## SIB 64 05 21

2022-04-19

## RATTLING NOISE PERCEPTIBLE IN VEHICLE INTERIOR WITH AC ACTIVATED

This Service Information Bulletin (Revision 1) replaces SI B64 05 21 **dated June 2021**.

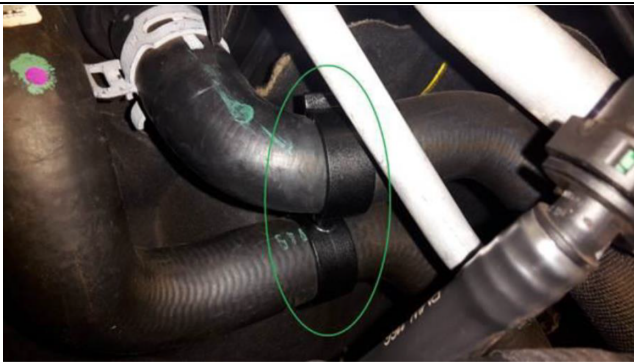
The refrigerant line double pipe and a clamp on the return line of the internal heat exchanger are in line with each other (in the direction of travel, on the left (driver) side of the engine compartment below/behind the DME).and are making contact.

The hoses are contacting here (arrow).
--	--

Mount a spacer (part number 11 53 7 537 923) in the engine compartment between the coolant hose feed and coolant hose return. The coolant hoses have to be turned about 10 to 15 degrees in the direction of the bulkhead.
